**Comments on presentation by John Abbott *et al.*: “Monte-Carlo update, PIE metric results, further benchmarking to fiber data”**

## Explanation for difference between Monte-Carlo results and 108-fiber results in John Ewen's presentation

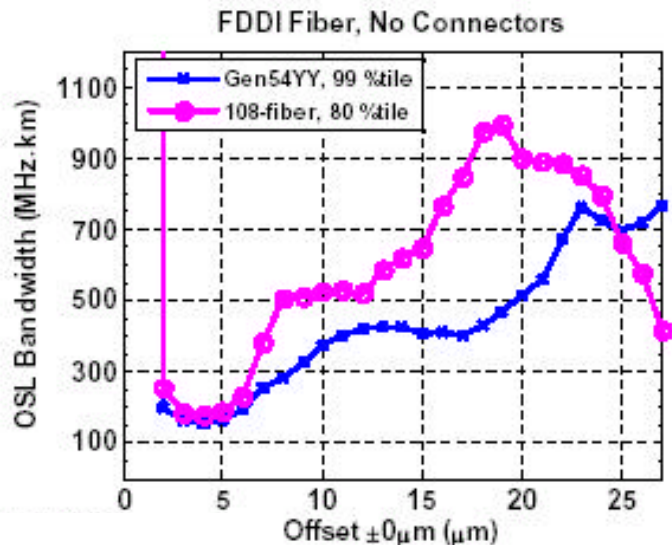
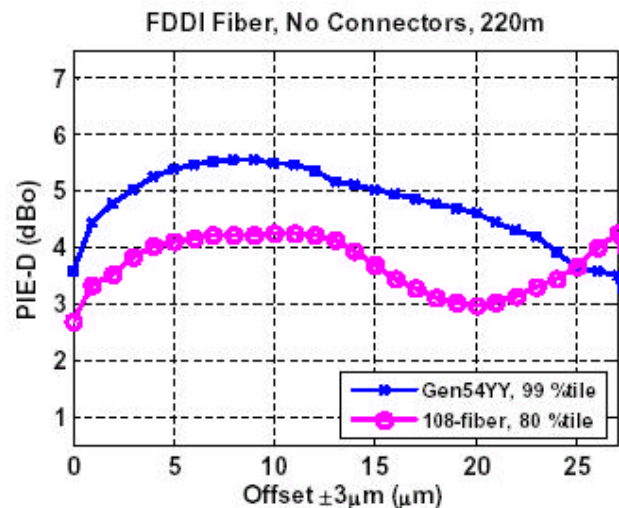
Good agreement in bandwidth at low offset, e.g. 5  $\mu\text{m}$ , but less so at high offsets

Clear implication of this result is that there are **differences in the offset DMD assumptions between the two models** – this is compatible with the differences in the scatter plots

PIE-D differences at high offsets particularly. We expect PIE-D to be affected across offset range as this is susceptible to 2<sup>nd</sup>-order effects (e.g. high-frequency tails in frequency response), which ties in with BW data

Clarity is needed in the justifications for the MC model, especially DMD slope

Example PIE-D at 300 m for 108-fiber model offsets of 17 mm, 20 mm and 23 mm

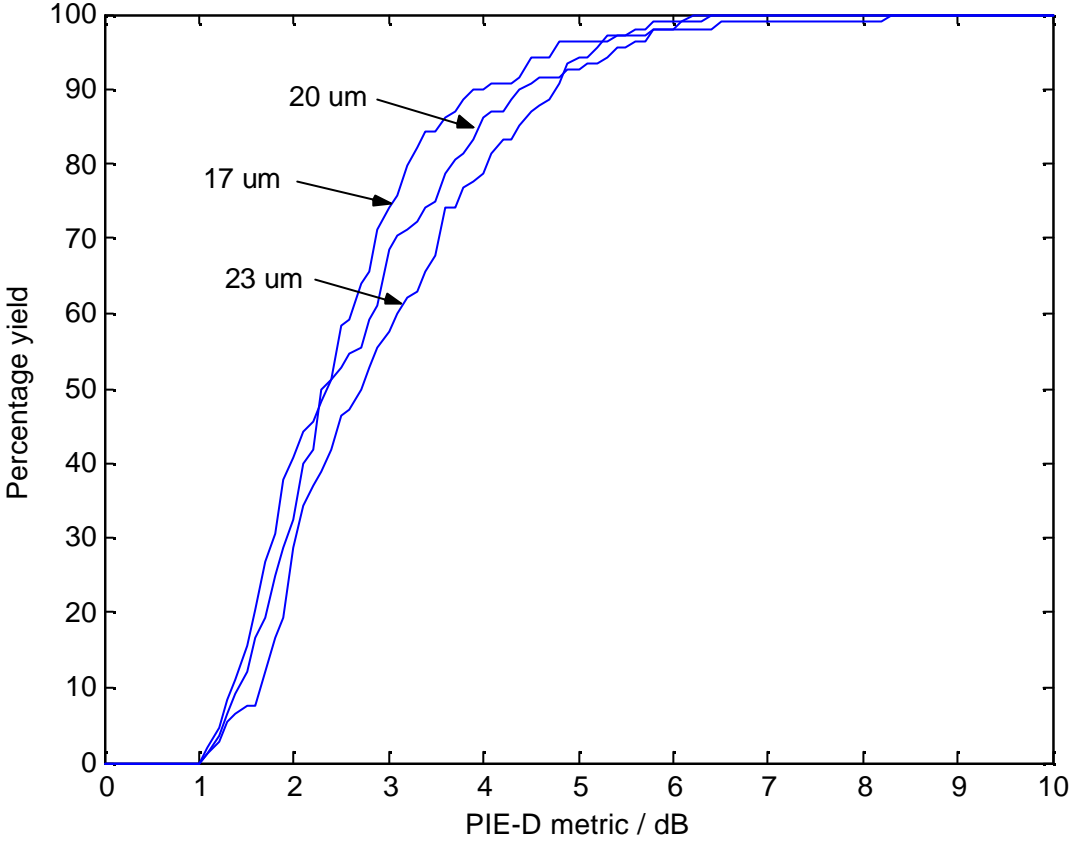
No connector effects included – see John Ewen talk, where **agreement between 108-fiber-model and Monte-Carlo model PIE metrics is shown to be high when connector effects are included**

Uncertain reason for choice of 17  $\mu\text{m}$  for the calculations – conventional method for comparison is to consider performance over a range of offsets (e.g. worst-case PIE over the 17  $\mu\text{m}$  to 23  $\mu\text{m}$  offset range)

17 um is not the most challenging offset – suggests that comparisons would be better made at an offset of 23 μm
